**DEFENSE NUCLEAR FACILITIES
SAFETY BOARD**

**DEFICIENCIES IN DOE STANDARD 5506-2007,
*Preparation of Safety Basis Documents for Transuranic
(TRU) Waste Facilities***

**Defense Nuclear Facilities Safety Board
Technical Report**

February 2018

Figure 1. Results of Monte-Carlo statistical sampling test of the MAR algorithm for the case of a uniform MAR distribution, using inventory sizes of $N = 100$ and $N = 1000$.

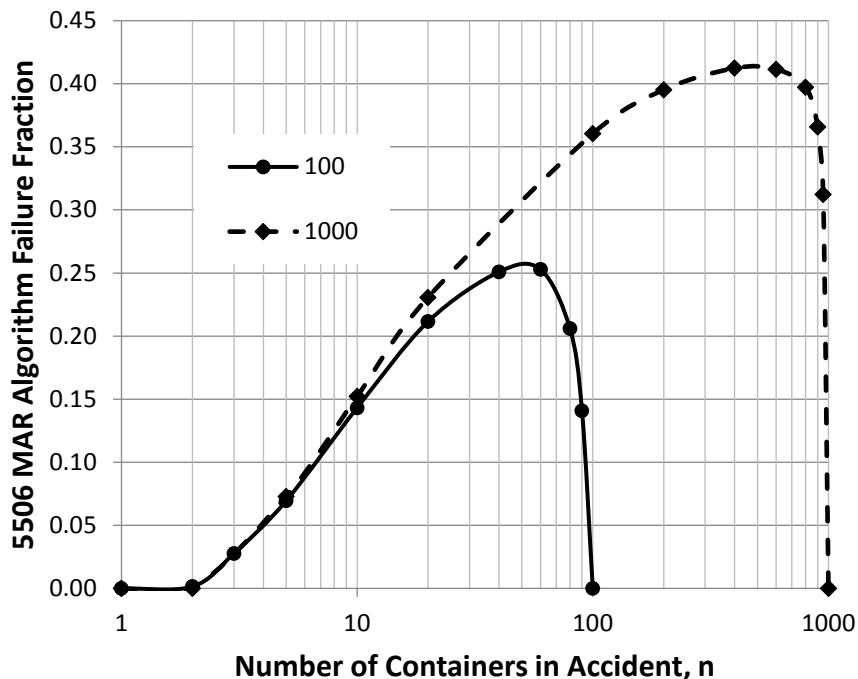
Statistical Tests—To explore the degree of conservatism of the statistical MAR methodology for practical cases of interest ($1 < n < N$), the Board’s staff performed Monte-Carlo statistical sampling tests of the algorithm for well-characterized waste containers. The Monte-Carlo statistical sampling tests involved assuming a MAR inventory of N containers, with some random distribution of MAR among the containers. Given an assumed distribution, the staff computed the *max*, 95th percentile, and *mean*. The staff then took random samples of n out of N containers. The staff computed the actual MAR for the sample and the MAR from the algorithm. Consistent with the Monte-Carlo approach, the staff repeated the sampling process many times. The staff computed the MAR algorithm failure fraction (fraction of cases where the algorithm does not bound the actual sample) based on the sampling results.

Figure 1 shows the results of the staff’s statistical test for the case of a uniform distribution of MAR within an inventory of waste containers. The staff considered two inventory sizes, $N = 100$ and $N = 1000$. The staff performed approximately 20,000 Monte-Carlo sampling trials to obtain each data point shown. The horizontal axis in Figure 1 shows the number of containers involved in the accident, n . The vertical axis shows the failure fraction of the statistical MAR algorithm. Figure 1 shows that the algorithm does not bound the sampled MAR anywhere in the range $1 < n < N$. Any time the failure fraction (fraction of cases where the algorithm does not bound the actual sample) is greater than zero, it means the algorithm does not bound the actual sample for a percentage of tests in the Monte-Carlo statistical sampling tests. The failure fraction exceeds 15 percent for a sample size of 11 to 89 drums out of a given inventory of 100 containers. The failure fraction exceeds 40 percent for a sample size of approximately 200 to 800 drums out of a given inventory of 1000 containers. The Board’s staff also evaluated other distributions of MAR inventories, including Gaussian, lognormal, and skewed, and obtained similar results.

- The Board's staff determined that the statistical MAR methodology outlined in DOE Standard 5506-2007 is not bounding, and is therefore not consistent with DOE Standard 3009-2014, which requires a bounding MAR to be used in hazard and accident analysis. Statistical tests performed by the Board's staff suggest that the statistical MAR methodology may have a high fraction of cases where it fails to bound actual MAR values.

- Regardless of the conservatism inherent in the statistical MAR methodology, or any improvements made to the algorithm, a requirement that the analyzed MAR bound the actual MAR in a given location would remove the potential for a non-conservative statistical-based MAR.

Figure 2. Variation of the mean MAR among rooms at WIPP.

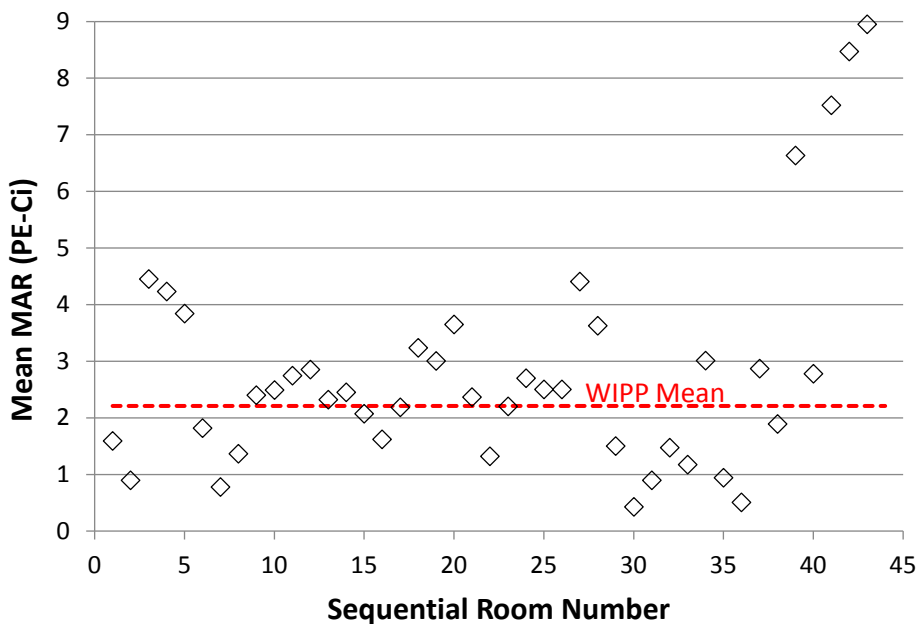
Evaluation of WIPP Inventory—The Board’s staff evaluated how the quantity of MAR in emplaced 55-gallon drums varies within the underground at WIPP. The staff calculated the mean MAR in 55-gallon drums for each of the 43 rooms in the WIPP underground. Figure 2 shows the calculated mean MAR in 55-gallon drums by room number. The dashed line shown in Figure 2 is the mean MAR for all 55-gallon drums at WIPP, 2.21 plutonium equivalent curies (PE-Ci). WIPP uses the mean MAR for all 55-gallon drums underground at WIPP when applying the statistical MAR methodology. However, Figure 2 shows that the mean MAR per room varies considerably in the WIPP underground. The Board’s staff concluded the variability in MAR per room is not random statistical variation, since the rooms contain a large number of drums (approximately 2,000 per room on average). The results shown in Figure 2 suggest that bias associated with individual waste transfer campaigns from different sources contributed to the variation. The staff’s conclusion calls into question the conservatism of the statistical MAR methodology, which relies on the global mean MAR to compute the MAR involved in a localized accident.

- The staff's analysis of MAR in the WIPP underground demonstrates that relying on global waste inventory for formulation of key inputs to the statistical MAR algorithm in DOE Standard 5506-2007 may not be appropriate.

Figure 3. DOE Standard 5506-2007 interpretation of aircraft and vehicle crash assumptions.

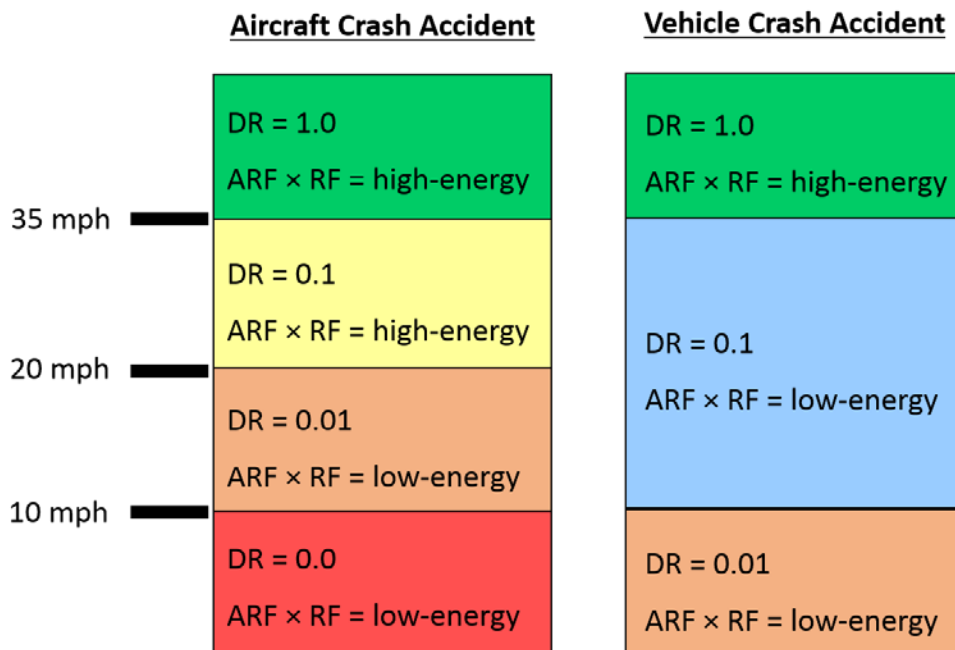
The guidance in DOE Standard 5506-2007 for estimating a radioactive material release due to a vehicle crash or aircraft crash into TRU waste containers does not provide sufficient detail to ensure consistent and conservative application across all TRU waste facilities. Furthermore, the lack of detail has contributed to inconsistent application of damage ratio and airborne release fraction times respirable fraction (ARF×RF) values for vehicle and aircraft crashes. Figure 3 illustrates how aircraft and vehicle crash accidents have applied different combinations of damage ratio and ARF×RF as a function of impact velocity, based on interpretation of guidance provided in DOE Standard 5506-2007.

Low-Energy vs High-Energy vs Catastrophic Impacts—The ARF×RF values cited in DOE Standard 5506-2007 can differ by an order of magnitude, based on whether they are classified as low-energy or high-energy impacts. DOE Standard 5506-2007 states that the high-energy impact ARF×RF values are applicable to a container fall from the fifth tier of stacked drums. This equates to a fall height of approximately 13.7 feet. A 13.7-foot fall height results in an impact velocity of approximately 20 miles per hour. A commonly used method in the aircraft crash accident analysis is to use the impact velocity calculated for a 13.7-foot fall height (i.e., 20 miles per hour) as the threshold above which high-energy impact ARF×RF values are applied.

When evaluating ground vehicle crash accidents, the high-energy impact ARF×RF values are generally not applied unless vehicle speeds are expected to be greater than 35 miles per hour, which is inconsistent with the 20 miles per hour threshold commonly used in aircraft crash

The damage ratios recommended in DOE Standard 5506-2007 differ by an order of magnitude, based on whether the impact is a result of a moderate to severe stress or a catastrophic stress. DOE Standard 5506-2007 assumes a catastrophic stress to be the result of an impact speed greater than 35 miles per hour. However, DOE Standard 5506-2007 does not offer guidance to the user on how to account for differing vehicle mass and size. The kinetic energy and momentum of the vehicle depends on both the mass and speed. Determination of the maximum possible vehicle speed at the facility is not standardized since DOE Standard 5506-2007 allows for speed restrictions due to the “physical layout of the facility/size and associated obstacles.” While the physical layout needs to be considered to evaluate a credible event, a formalized process for determining the potential maximum speed would improve how the physical layout and/or obstacles are used to define the initial conditions of the event. Similar to the vehicle barrier analysis performed for TWPC [7], a parametric evaluation could be performed using the known distances available for vehicle acceleration before impacting a waste container. The parametric evaluation could consider the possible vehicle types and account for varying acceleration estimates for each vehicle type.

In addition, the application of a zero damage ratio for impacts occurring at less than 10 miles per hour has been inconsistently applied between aircraft and vehicle crash accidents. Aircraft crash accident analysis at ORNL–TWPC [6] applies a zero damage ratio once enough momentum has been transferred to waste containers to slow down the aircraft and impacted waste containers to 10 miles per hour. Application of a zero damage ratio for impact speeds less than 10 miles per hour is based on the 4 foot drop qualification for Department of Transportation Type A containers, which equates to an impact velocity of 10 miles per hour. Appendix C of DOE Standard 5506-2007 endorses the use of a zero damage ratio for drums that fall less than 4 feet. However, Appendix C then defines low speed vehicle impacts as occurring at less than 10 miles per hour and recommends applying a damage ratio of 0.01. As a result, the source term assumptions for low speed impacts (10 miles per hour or less) differ depending on whether the impact is initiated by an aircraft or a vehicle.

DOE Standard 5506-2007 should clearly provide the thresholds that determine which damage ratio and ARF×RF should apply to both the aircraft and vehicle crash accidents, such that application is consistent for all relevant accident scenarios. Multiple variables must be

- Establishing thresholds that define the severity of impact stresses, and
- Selecting assumptions and methods for evaluating vehicle and aircraft impacts on TRU waste facilities and containers.
